RE: 7140 ABBOTT AVE., MIAMI BEACH, FL. 33141

DRB COMMENTS, DATED 06/05/20

Landscape Related Comments:

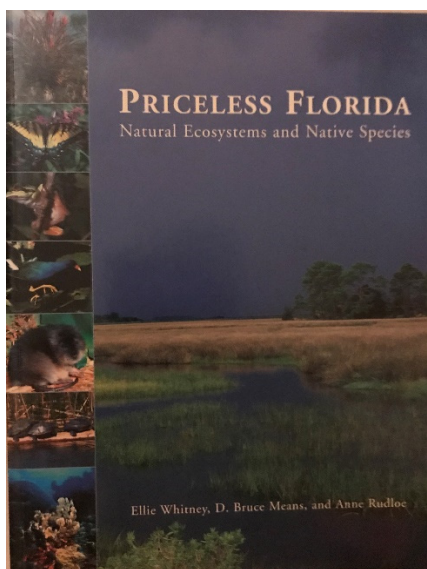
- Bioswale area – can be unsafe – CEPTED

RESPONSE: TREE SPECIES CHANGED PER DRB COMMENTS TO BALD CYPRESS AT BACK OF BIOSWALE (25' O.C.) AND LOWER LEVEL NATIVE GROUNDCOVERS HAVE BEEN CHANGED OUT FOR CPTED CONSIDERATIONS.

ALL OF THE PLANTINGS IN THE BIOSWALE ARE NATIVE SPECIES AND ARE NATIVE TO "BASIN-WETLANDS" ENVIRONMENTS, PER "PRICELESS FLORIDA, NATURAL ECOSYSTEMS AND NATIVE SPECIES" BY ELLIE WHITNEY, D. BRUCE MEANS, AN D. ANNE RUDLOE I. E NATIVE BALD CYPRESS, NATIVE DWARF FAKAHATCHEE GRASS, NATIVE MUHLY GRASS AND NATIVE SPIDER LILY.

HEIGHTS OF THE UNDERSTORY PLANTINGS NORMALLY WILL NOT EXCEED 24" TO ALSO PROVIDE VISIBILITY AND ADHERE TO CPTED GUIDELINES.
